Work Order ID 64158 PRELIMINARY ISSUE

Hinge

Α	NEW ISSUE				SC	10.12.15
REV.	· · · · · · · · · · · · · · · · · · ·			DESCRIPTION	BY	DATE
DESIGN		SC		DART AEROSPACE LTD		
DRAWN SC		Ç	HAWKESBURY, ONTARIO, CANADA			
CHECKE	ED	W)	DRAWING NO.		REV. A
MFG. AF	PR.	Ken	<	D4298	S	HEET 1 OF 1
APPRO\	/ED	JW	21	TITLE		SCALE
DE APPI	₹.	-/	H-	CHART HOLDER (AW 139)	_	NTS
DATE 10.12.15				COPYRIGHT @ 2010 BY DART AEROSPACE LTD THIS DOCUMENT IS PRIVATE AND CONFIDENTIAL AND IS SUPPLIED ON THE EXPRESS CONDITION THAT IT IS NOT TO BE USED FOR ANY PURPOSE OR COPIED OR COMMUNICATED TO ANY OTHER PERSON WITHOUT

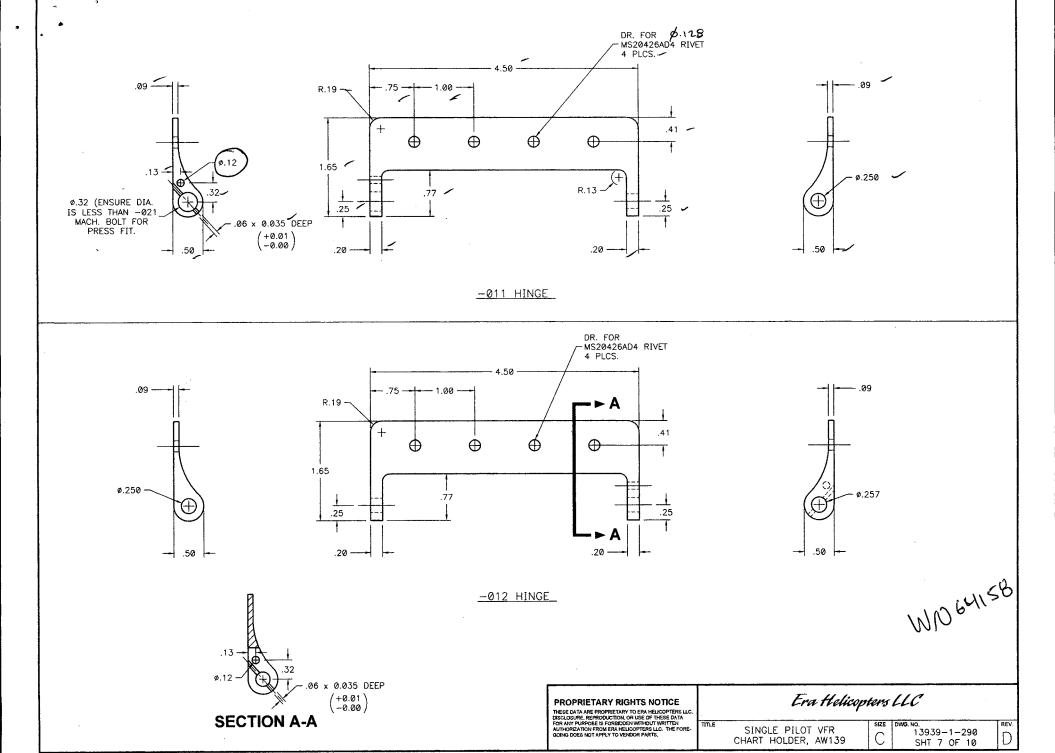
NCR:		WORK ORDER NON-CONFORMANCE (NCR)												
		Description of NC		Corrective Action Section B	Verification	Approval	Approval							
DATE	STEP	Section A	Initial Chief Eng	Action Description Chief Eng	Sign & Date	Section C	Chief Eng	QC Inspector						
10:12:17	105	Ø.098" not corrected on ERA Des. D arming.	1	hole is 0.098 per red Rivet installed upon Assiy? ERA Peu. A drawing monkap	F2 10.1	2117								
1		Rc'. 3rd partya closign	Posicer	ERA Peu. A drawing monkap. dim was not recurled on FAI Aduise ERA OF the desiration			Osian	10.12-17						
				See	atted	ed e-mail								
	·

Thanks David, at the same time would you know what kind of finish is required on the assembly, most of our interior parts we alodine and then powder coat black sandtex, this black is satin and prevent any glare. If this is what you would like please let me know, or fwd this to whoever can help me out with this.

Good morning David, we found a problem with the location of the rivet hole for assembling -024 with -006 and -007, I attached a picture of -006 same problem with-007, also it seems like it would be better to use AD3 rivets instead of AD4's it would leave a bit more meat on the -024. Let me know if we can just transfer the hole location from -024 into -006 and -007 for this unit only and if you would like to go with the AD3 rivets.

Yes that would be perfect!

Hi Eric. Yes, please make the needed adjustments to the rivet hole locations. Also, I agree that AD3's would be better than AD4's.
